BRANDING IRON AT STERLING RANCH FILING NO. 1

A REPLAT OF TRACT BB, "STERLING RANCH FILING NO. 1", SAID TRACT BEING A PORTION OF THE E 1/2 W 1/2 OF SECTION 33, TOWNSHIP 12 SOUTH, RANGE 65 WEST OF THE 6TH PRINCIPAL MERIDIAN, EL PASO COUNTY, COLORADO

FINAL PLAT
BRANDING IRON AT
STERLING RANCH FILING NO. 1
JOB NO. 09-006
DATE PREPARED: 10/30/2017
DATE REVISED: 07/30/2018

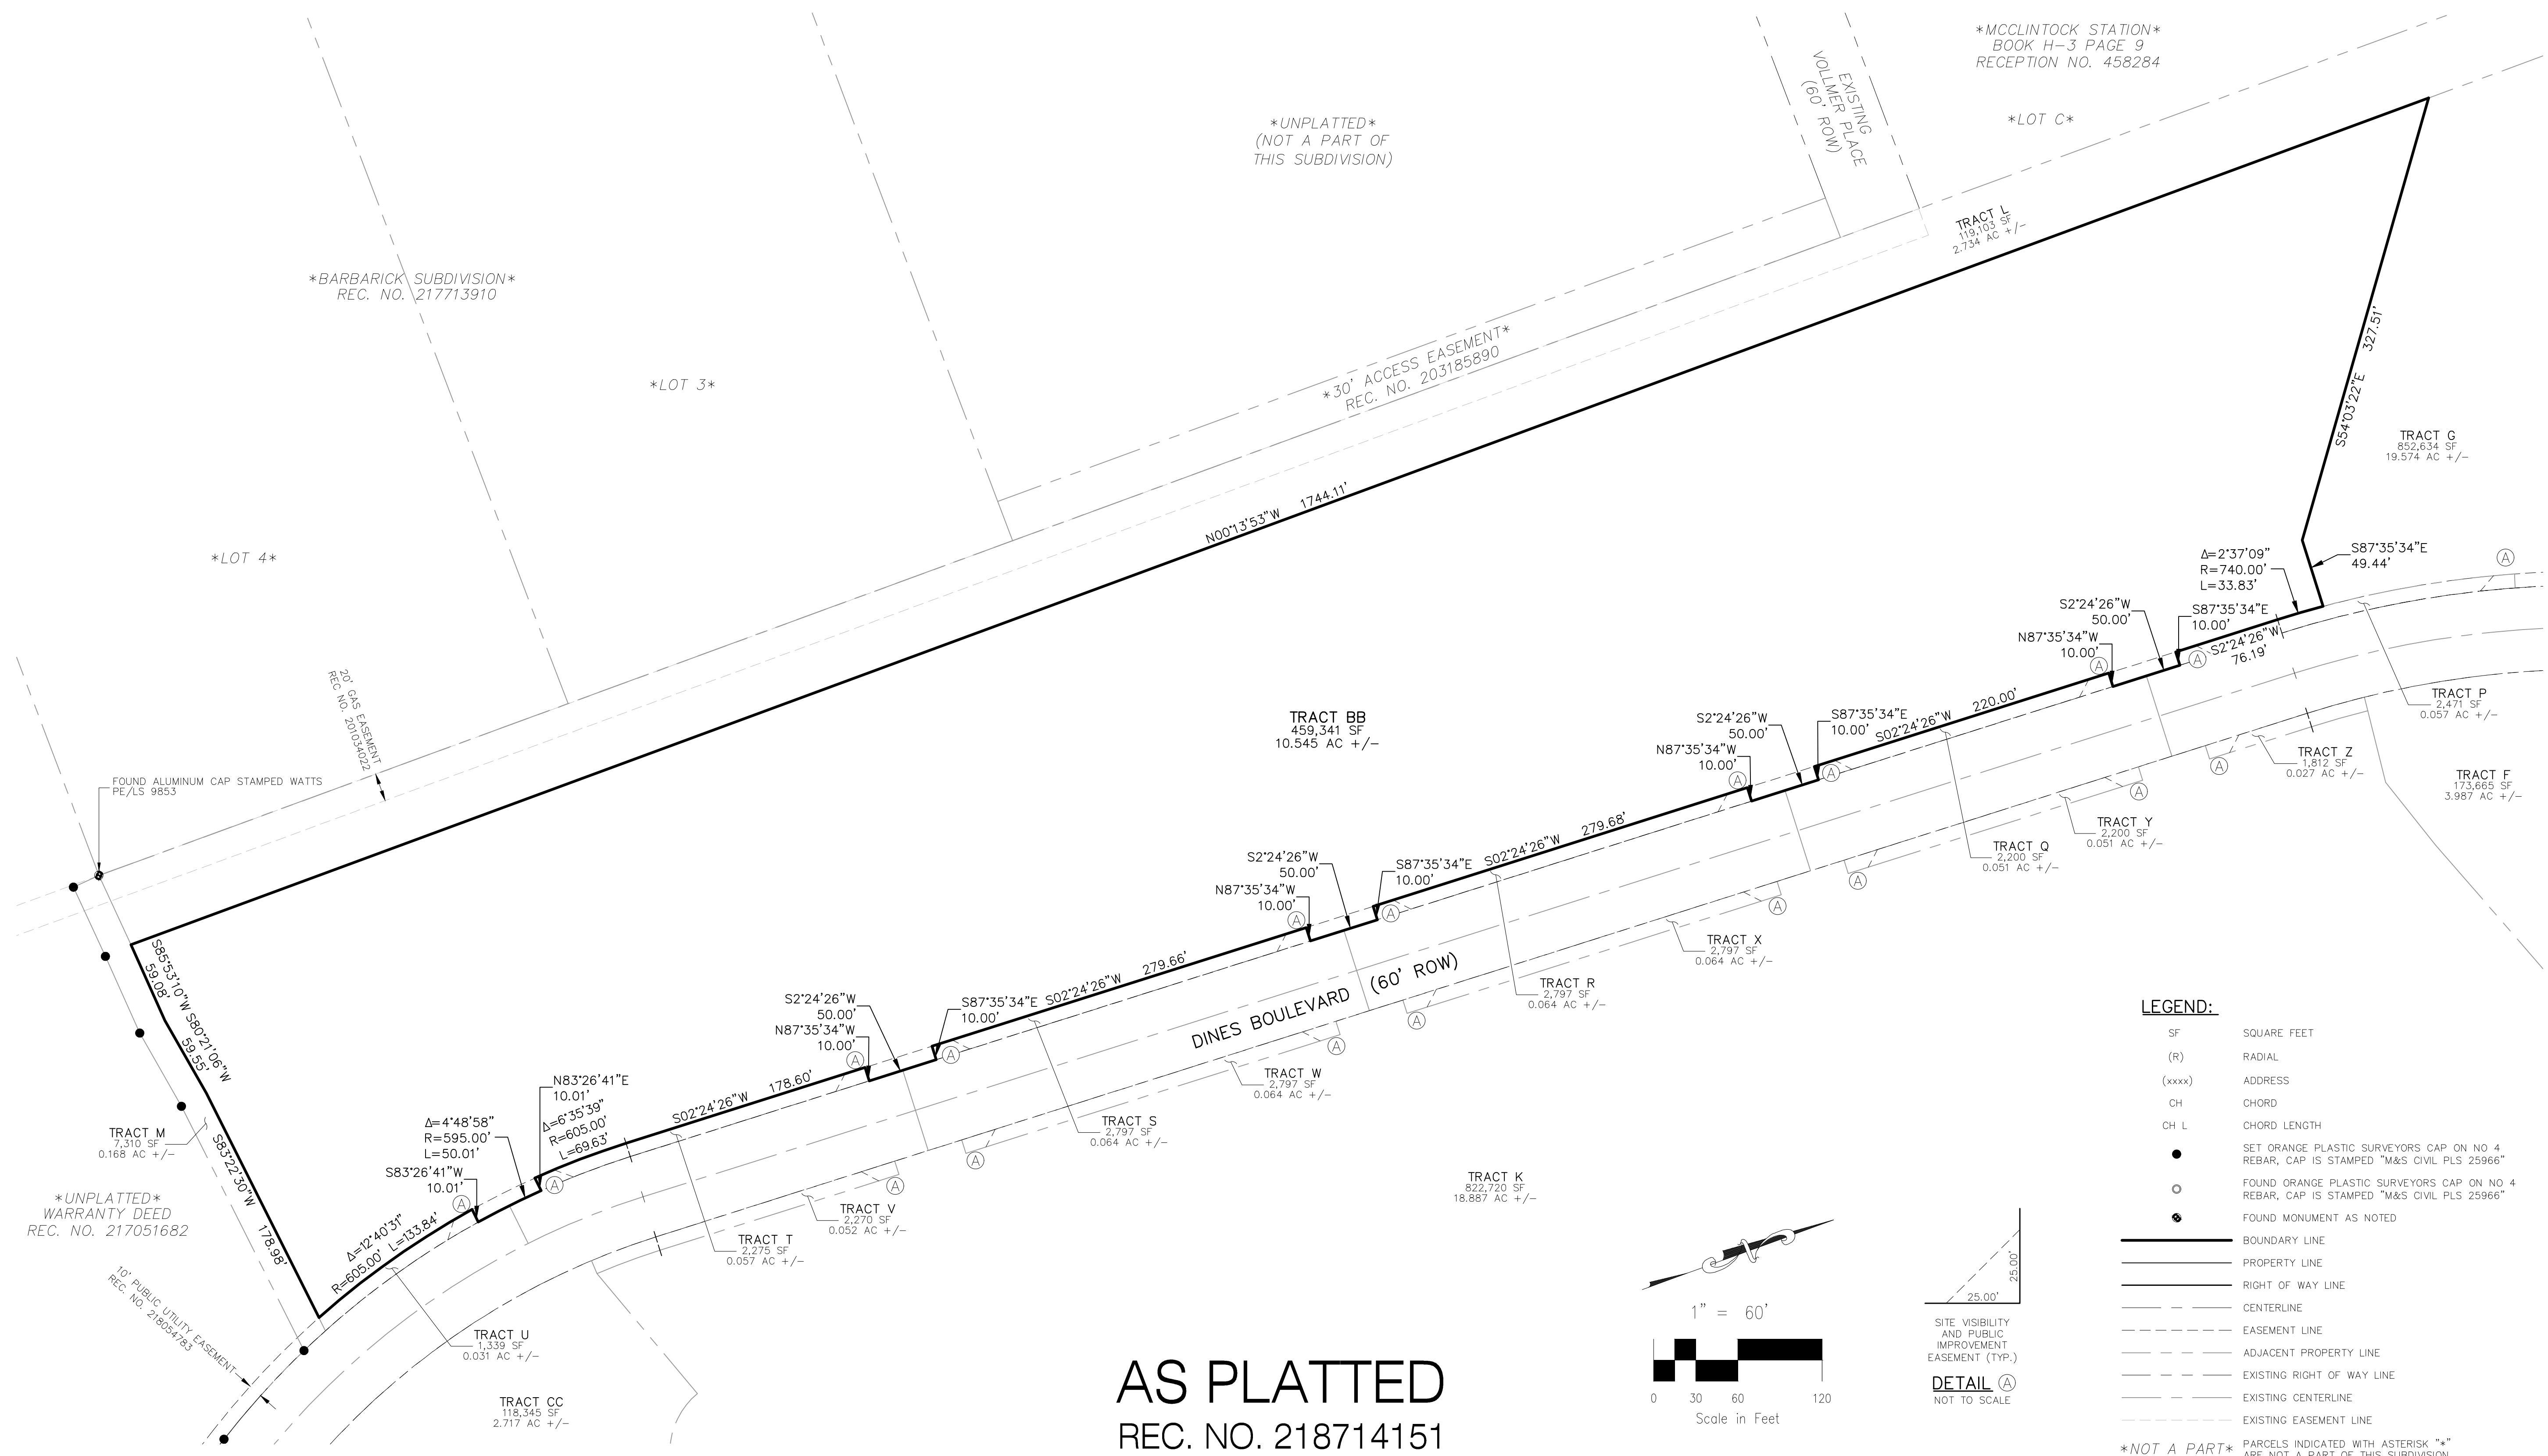
You need to put the relative info from a title search post the filing 1 plat and changes since June.

Easment for the access note _____

Escrow Agrrment note shall be aded and the reception no. _____

You need to put the relative info from a title search post the filing 1 plat and changes since June.
